Project	The Falls on Refugee Road	Addendum Number	3
Project Number	23446	Date	07/10/2025
To	All Bidders

This addendum contains changes to the requirements of the bidding Documents, Project Manual and Construction Drawings which have been issued to date. Such changes are to be incorporated into the Construction Documents and shall apply to the work in the same meaning and force as if they had been included in the original documents. Wherever this Addendum modifies a portion of a paragraph of the Project Manual or a portion of any Drawing, the remainder of the paragraph or Drawing shall remain in force.

Moody Nolan

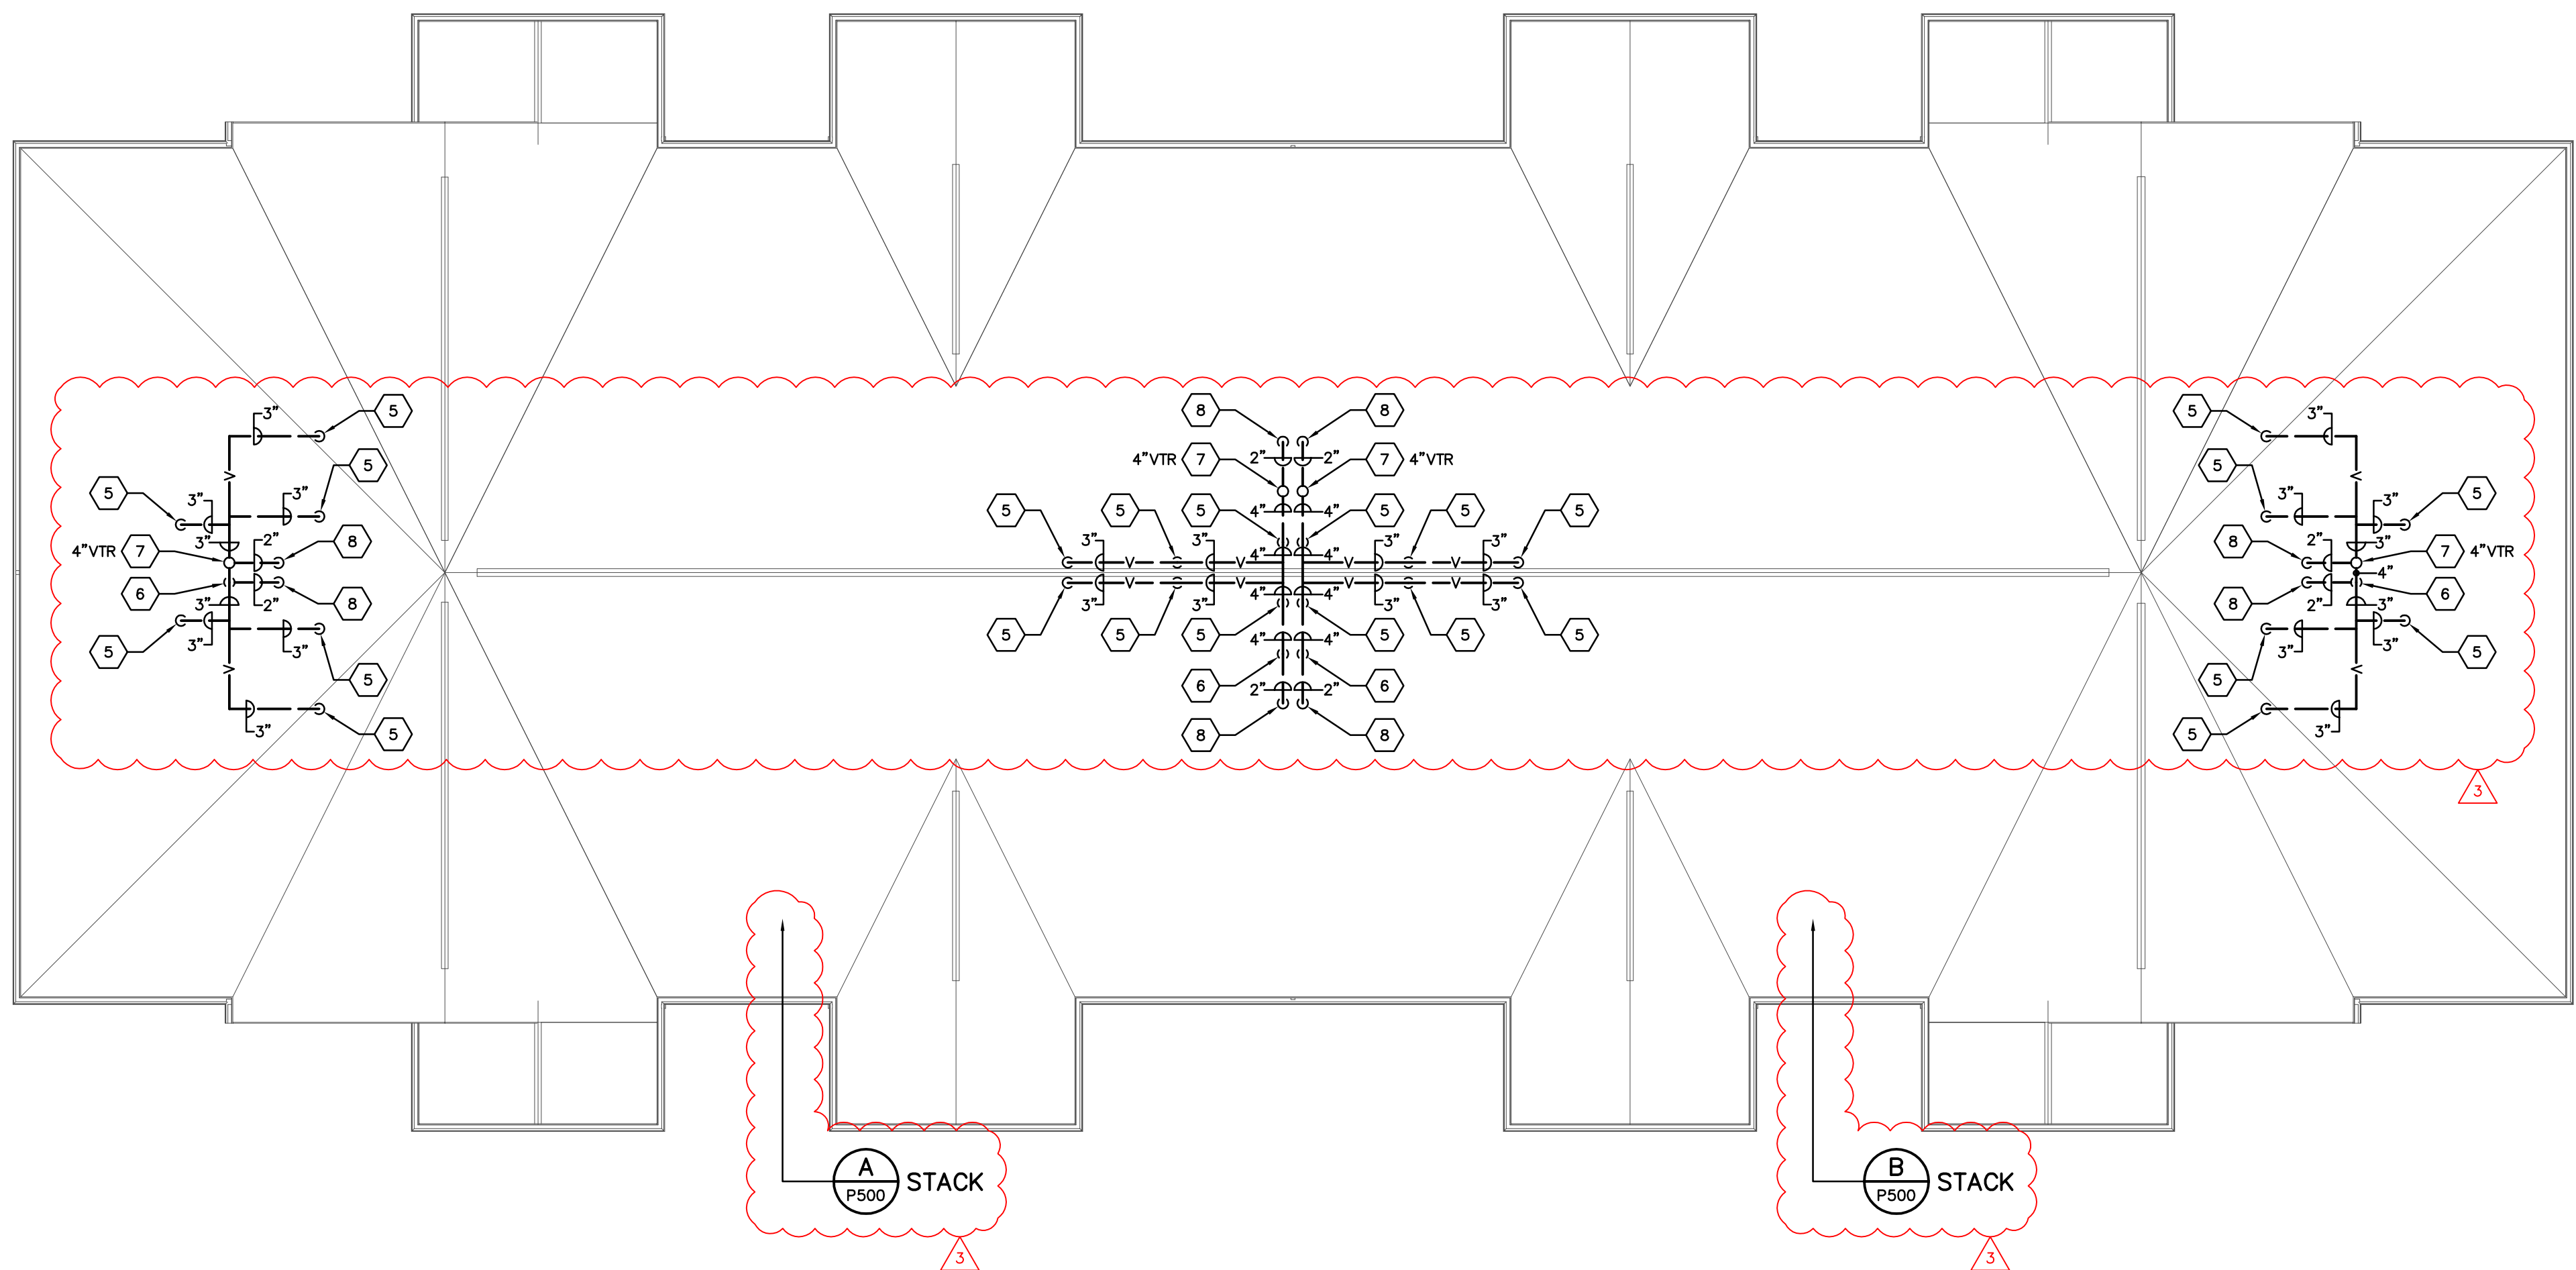
Sheet P101-A

1. Revised sanitary piping layout.
2. Revised Coded Notes 4, 6, & 7.
3. Added stack diagram designations.

DRAWING TITLE:
**BUILDING A - LEVEL 03 & ATTIC
PLUMBING PLANS**

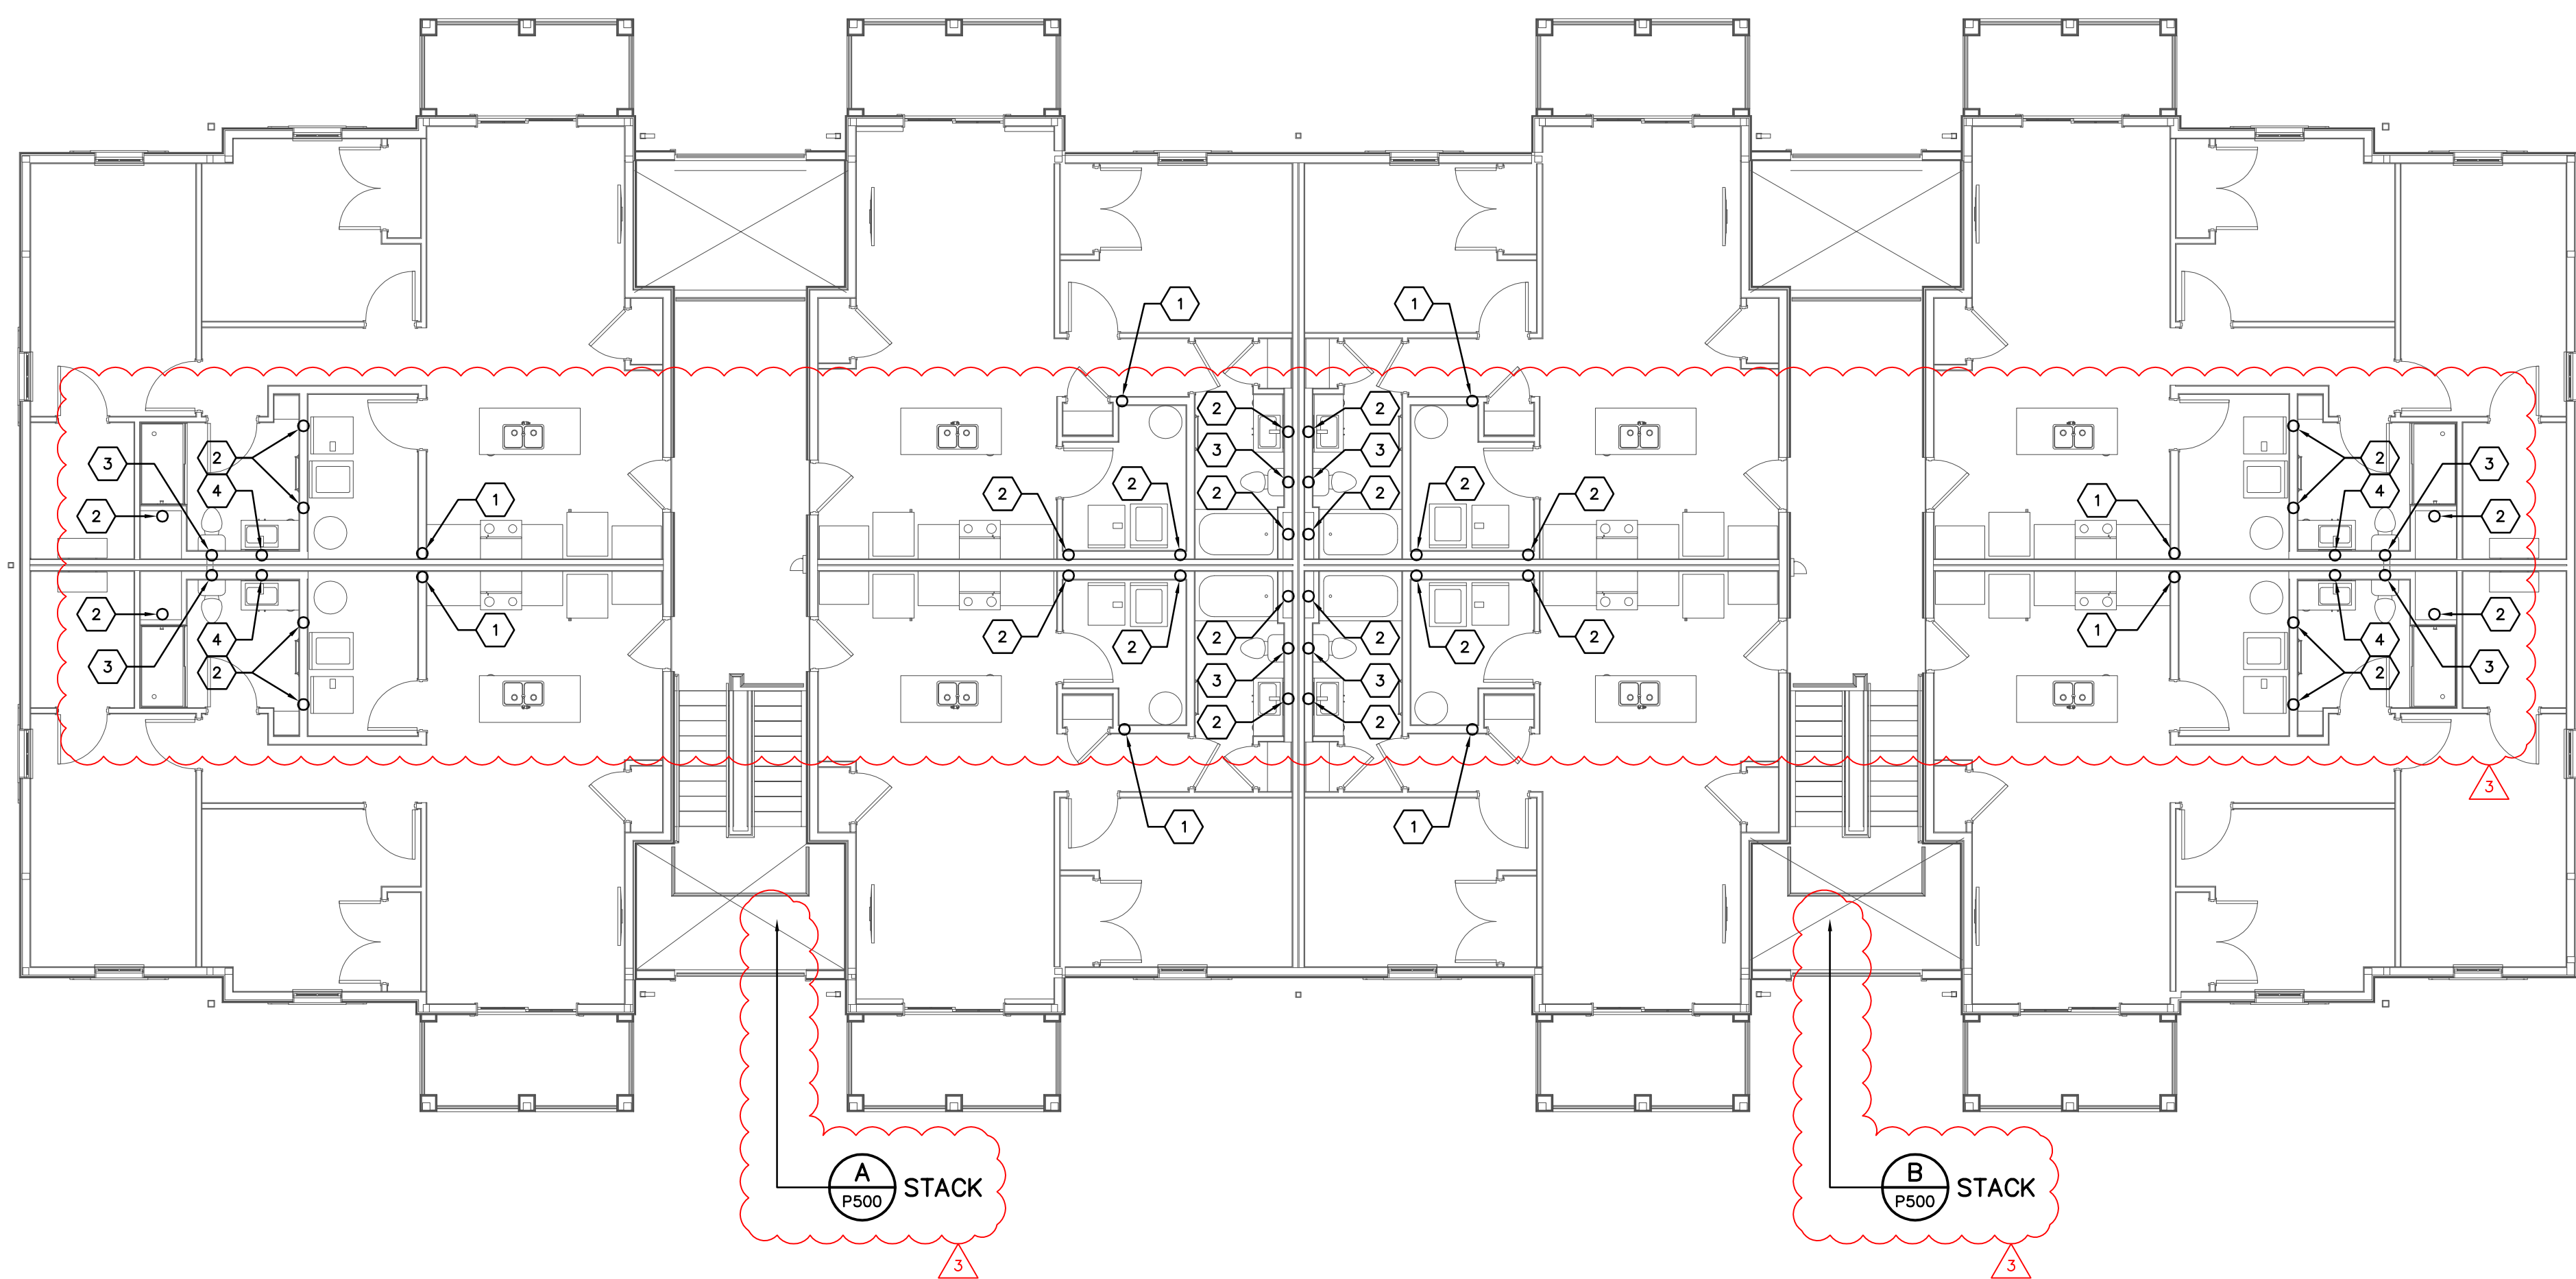
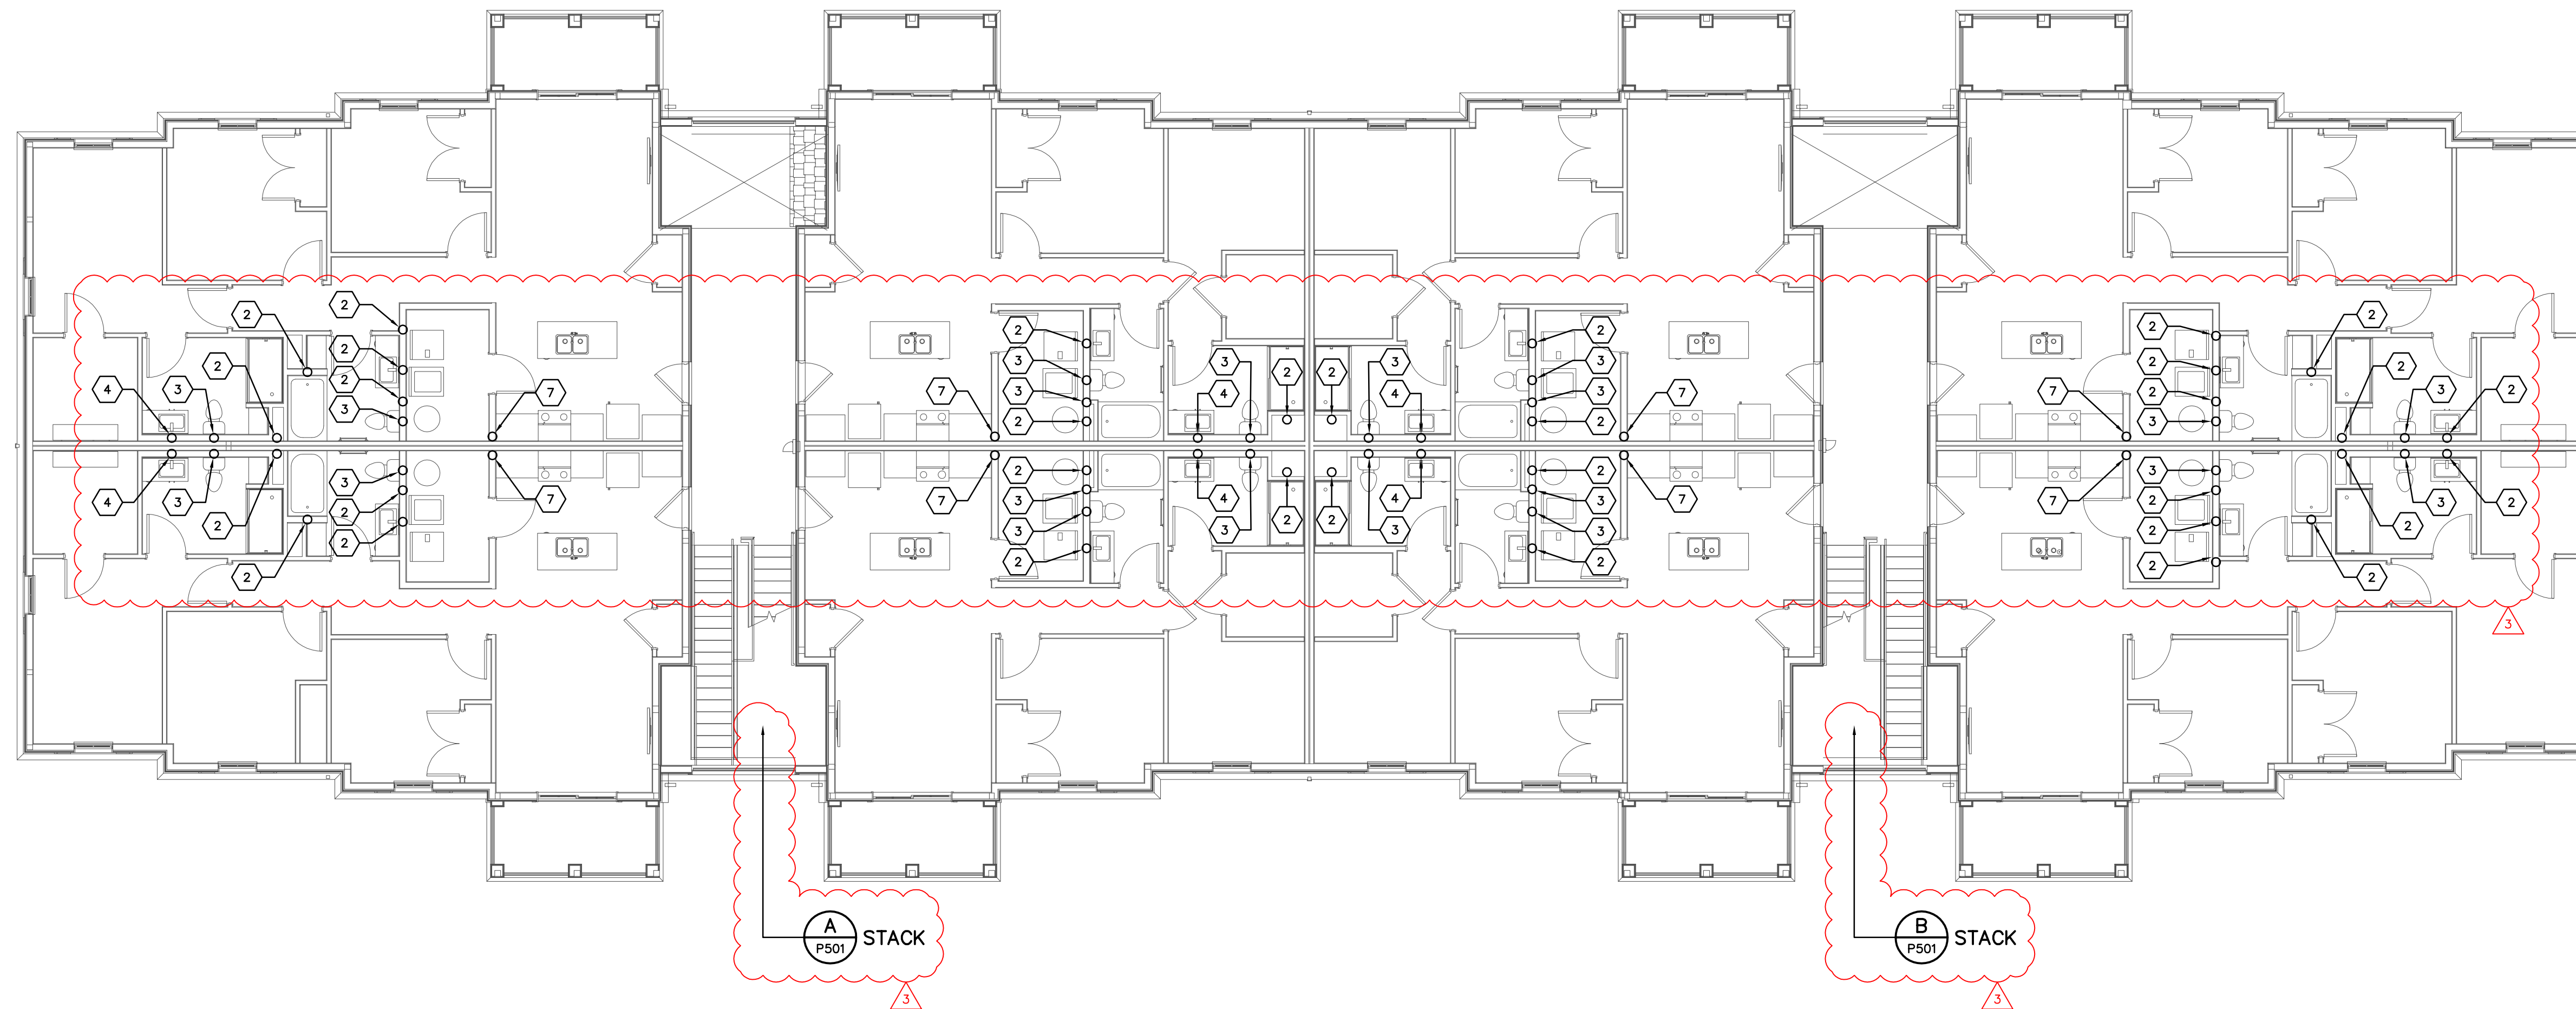
Sheet P102-A

1. Revised sanitary piping layout.
2. Revised Coded Note 4.

3. Added Coded Note 8.
4. Added stack diagram designations.
5. Renamed roof plumbing plan as attic plumbing plan.
6. Revised attic vent piping.
